Memorandum

To: Town of Washington Planning Board
From: Aaron Werner, AICP
Date: December 1, 2023
Re: 515 Woodstock Road Subdivision
cc: Timothy Clear and Johna Lee Clear (Property owner)
Douglas E Larson – Larson Architecture Works PLLC (Applicant / Architect)
Meghan Clemente (PB Attorney)
Alicia Moore (AKRF, Inc.)

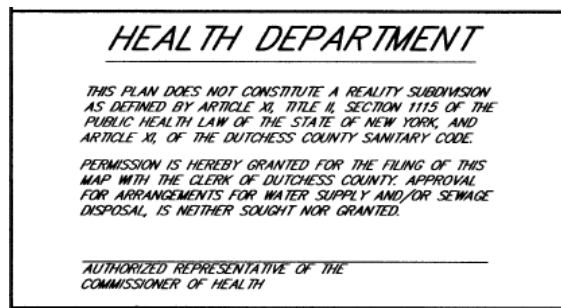
12. This application for a non-realty subdivision requires permission to file from the Dutchess County Health Department, which the Applicant must demonstrate has been received prior to the Planning Board Chair signing of the final plat. An appropriate signature block for the Health Department (similar to below) should be added to the plat.
